INFORMATION REQUEST
(Given under Section 12 of the Development Assessment Rules)

Street Address: 97 – 113 Davidson Street PORT DOUGLAS
Real Property Description: Lot 1 and Lot 2 on RP723702 & Lot 3 & Lot 4 on RP909815
Local Government Area: Douglas Shire Council

Application Number: CA 2023_5420/1
Approval Sought: Development Permit
Nature of Development Proposed: Combined Application
Description of the Development Proposed: Accommodation, Multiple Dwellings & Reconfiguring a Lot (4 Lots into 45 Lots & Common Property)

Figure 1: Zone of Influence for DN150 Sewer Along Western Boundary of Development

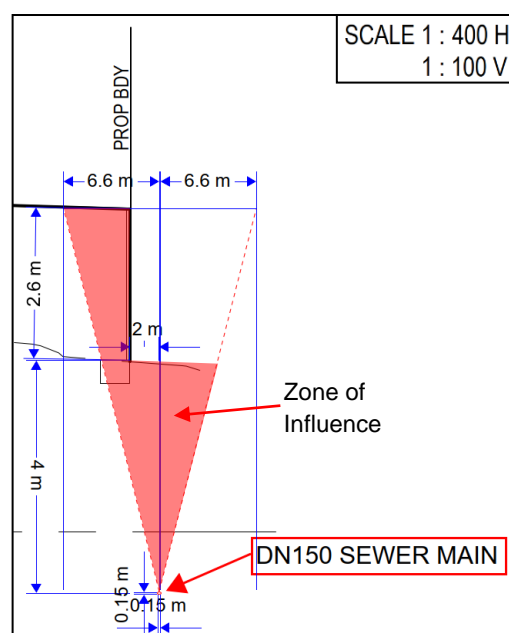
14. Concern is raised regarding loading of the proposed realigned sewer due to the retaining wall along the development's western boundary. Specifically, the consequences of building a trunk sewer 4m deep and offset 2m from the toe of a 2.6m retaining wall.

The zone of influence for a sewer of this depth extends approximately 4.6m into the development footprint (refer annotated figure below).

The Applicant is requested to confirm how the interaction between the foundations of the retaining wall proposed along the length of the development's western boundary and the new 150mm trunk sewer will be designed and constructed independent of one another.

Cross sections showing the proposed retaining wall footings and trunk sewer arrangement are requested to support the discussion.

Figure 2: Vegetation Mapping Adjacent Development (SARA DAMS Mapping)

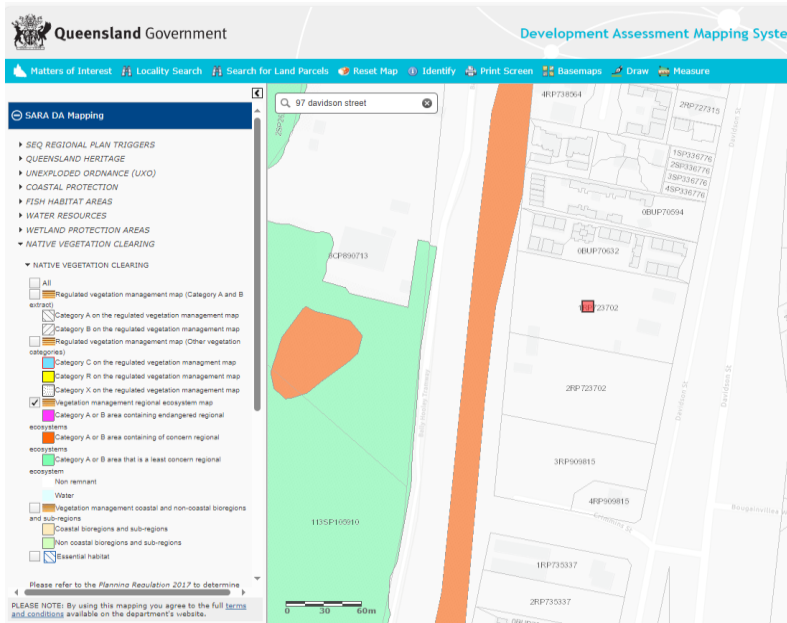
Advice Note: Officers are concerned that the 2.6m high retaining wall, stormwater outlet infrastructure, and realigned 4m deep 150mm diameter trunk sewer proposed along the western boundary will be very detrimental to the wellbeing of existing trees in this area (outside the development).

In addition, vegetation west of the development site is classed as “area containing of concern regional ecosystem” (SARA Development Assessment Mapping System) and mapped as Category B Remnant Vegetation (Qld Globe). Refer Figure 2 and 3 below.

The Applicant is requested to engage a suitably experienced and qualified arborist to assess each tree located within 10m of the development's western boundary.

The assessment is required to indicate which trees are at risk of being harmed or destroyed as a result of the proposed retaining walls, trunk sewer infrastructure, and stormwater outlet infrastructure. The assessment should also discuss the measures required to protect any trees at risk of being harmed or destroyed. Reference should be made to the vegetation mapping west of the site.
